**From:** Barnes, Joe  
**Sent:** 17 October 2019 14:43  
**To:** 'Mike Gregory'  
**Cc:** 'james.smalley@redrow.co.uk'; 'Dave Griffin'; Clark, Stuart  
**Subject:** RE: Tree Works at Allerton Priory  
**Attachments:** MG.4815.Condition 13 tree works.REV A.SEP19.(Plans attached).pdf

**Development at Allerton Priory (160/1101) – removal of trees for management.**

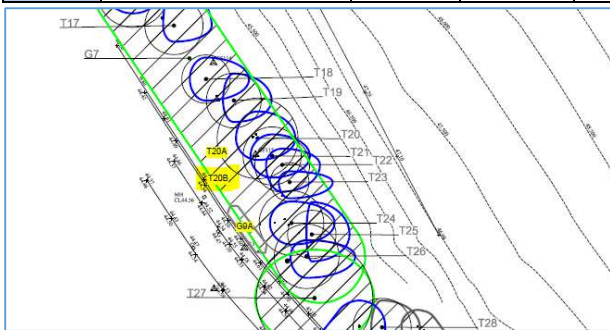
Ref. No.	Species (Common name)	Est. height (M)	Est. dia. (in mm)	Age Class	Vigour	Structure	Condition Notes	Recommendations
<b>T20B</b>	<b>Sycamore</b>	8	170	Young	Good	Poor	Suppressed self seeded tree growing adjacent boundary wall	Fell tree due to suppressed growth over road and its close proximity to boundary wall.

Nine Sycamores (G3, T20B, G9A, T32A, T38A) are growing within larger woodland groups and the overall view of these areas in terms of amenity will remain unchanged.

Ref. No.	Species (Common name)	Est. height (M)	Est. dia. (in mm)	Age Class	Vigour	Structure	Condition Notes	Recommendations
T81B	Holly	6	300 (at base)	Early Mature	Good	Fair	Tree causing direct damage to wall.	Fell due to wall damage.

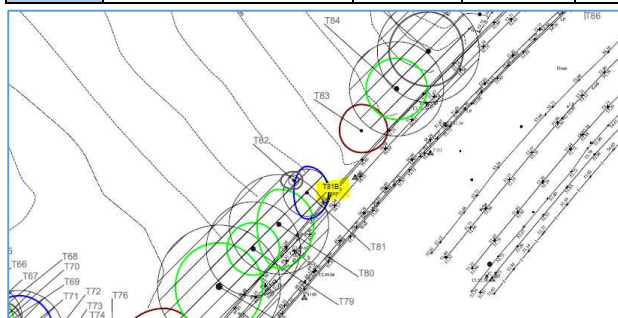
As T81B grows in a relatively open aspect, it is to be replaced. The replacement tree is to be a native Holly (unless another species is specified by the Local Planning Authority). This shall be a minimum of full standard stock with trunk height of some 1.8m height, trunk girth of 10-20 cm and a 25 litre pot size.

Holly (T81B) is situated directly adjacent to Woolton Road and does provide a low level of amenity as it is clearly visible from the public highway, however the tree has seeded adjacent to the wall and is impacting the structure. A replacement Holly of adequate planting size is proposed and will be set back from the wall to avoid future impact.

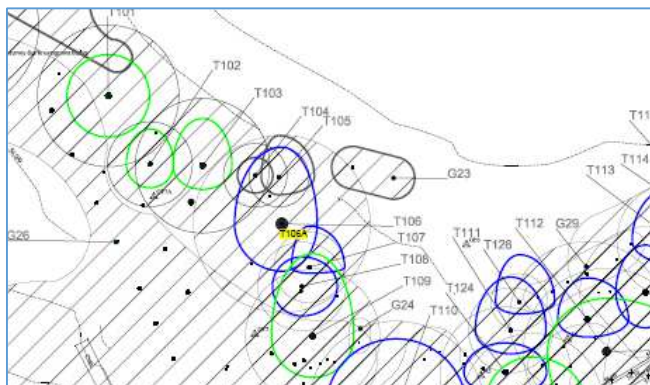
Ref. No.	Species (Common name)	Est. height (M)	Est. dia. (in mm)	Age Class	Vigour	Structure	Condition Notes	Recommendations
T106A	Holly	6	160	Early mature	Good	Good	Tree growing to south of the trunk of T106 (Sweet chestnut)	Fell holly tree as part of vegetation removal to allow placement of woodchip mulch to ameliorate the root-plate of T106.

A veteran tree, Sweet Chestnut T106 has been identified within the woodland at the site and amelioration with woodchip mulch is proposed as a treatment to promote the health and longevity of the tree. Holly (T106A) is a multi-stem tree growing within the trees canopy and will prohibit part of the implementation of the treatment. The veteran tree provides an important habitat and on balance the health of this tree far outweighs the loss of the small early-mature Holly. In addition the Holly provides a negligible amenity value as it cannot be viewed from any public vantage point.
